RE: Docket No. 51998 – Application of the City of Burleson to Amend its Certificate of Convenience and Necessity in Johnson County

### Memorandum

**RE:** Docket No. 51998 – Application of the City of Burleson to Amend its Certificate of

# Sewer CCN 2021 De-certification Detail Map

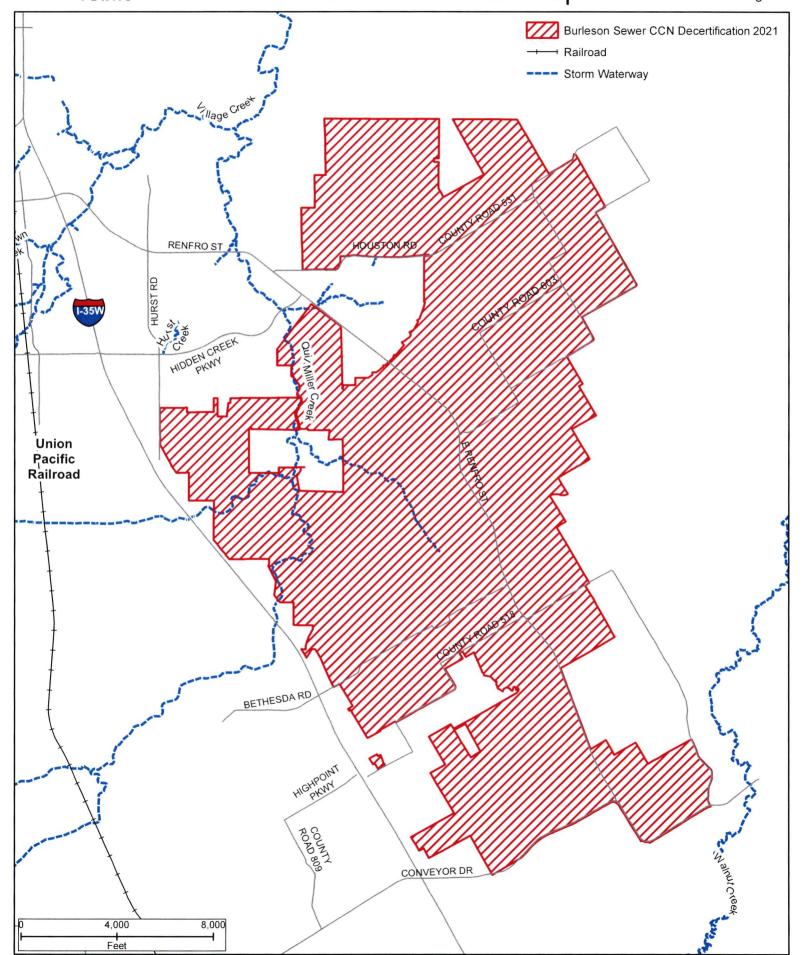
Staff has determined that the digital mapping data, general location and detailed maps submitted with the application on April 8, 2021 are deficient. The requested area provided in a shapefile format overlaps the existing certificated service areas for the City of Burleson (CCN No. 20358) and Undine Texas Environmental LLC (CCN No. 21019).

The detailed map must clearly show the outer boundary of the requested area in reference to the roads and highways located in close proximity to both the inside and outside of this large requested area. The general location map must show the requested area in reference to major highways and roads. The labeling of roads and highways on both maps, should not cover any portion of the outer boundary of the requested area.

Staff recommends that Burleson submit the following items to resolve the mapping deficiencies:

- A revised general location map identifying only the requested area, in reference to the nearest county boundary, city, or town.
- A revised detailed map identifying only the requested area, in reference to verifiable man-made and natural landmarks, such as roads, rivers, and railroads.
- Revied digital mapping data for the requested area, as a single polygon record, in

shapefile (SHP) format, georeferenced in either NAD83 Texas Statewide Mapping System (Meters) or NAD83 Texas State Plane Coordinate System (US Feet).
